## Seabrook Annulus Debris Interceptor Approach Velocities

During our January 21, 2011 conference call with the NRC concerning fiber erosion testing for Seabrook using a method that was acceptable to the NRC (ML101540221), the NRC requested the bases that the test velocities used in the Seabrook tests are applicable to the Seabrook containment and debris interceptors.

**Typical fiber debris hold-up at 0.517 fps**

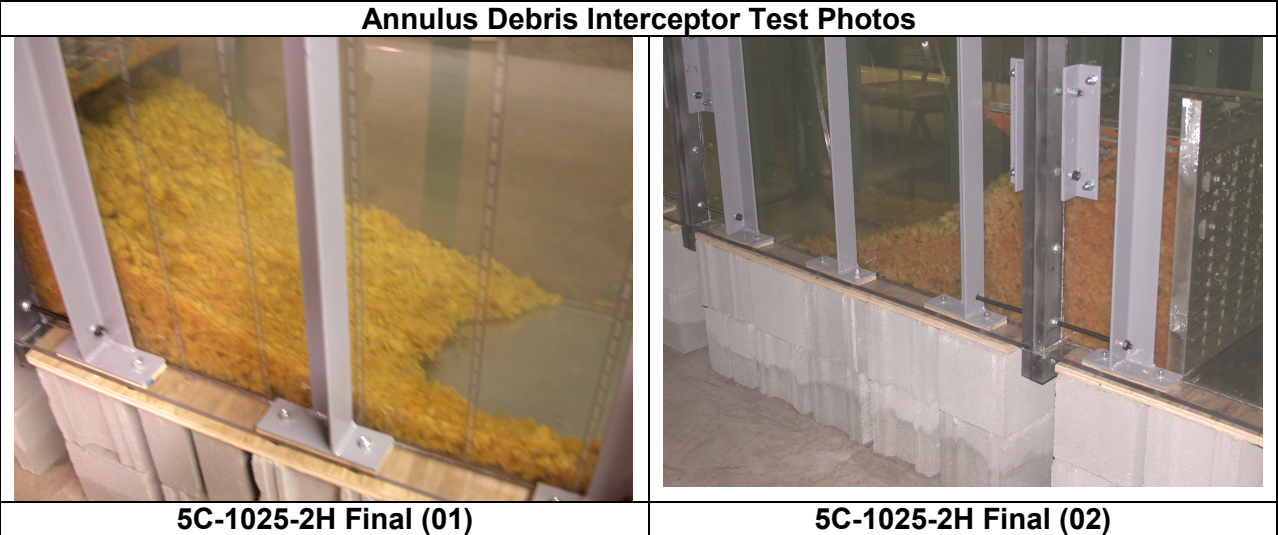
- At 0.384 fps and above, the debris hold up occurred at the debris interceptor and formed a triangular debris pile against the debris interceptor. The face of the debris pile is exposed to the debris interceptor approach velocity.

**Typical fiber debris hold up at 0.252 (500 gpm test flow rate) and 0.318 fps (635 gpm test flow rate)**

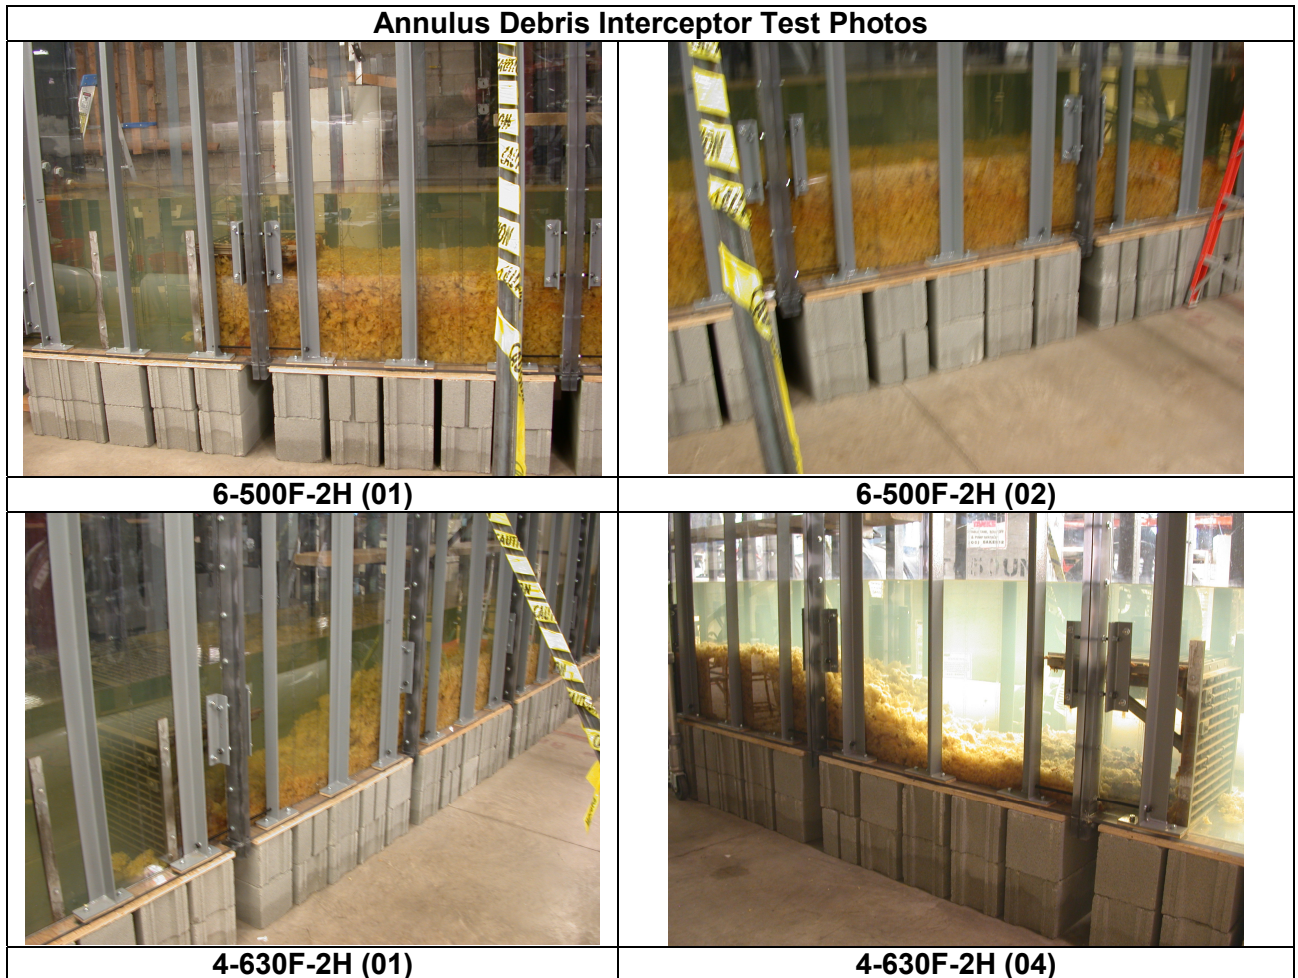
- At 0.318 fps and less, the debris hold up occurred ahead of the debris interceptor. The debris piled up and sunk to the floor as the flow field passed through the debris. This type of debris holdup would expose small fines to the full approach velocity.
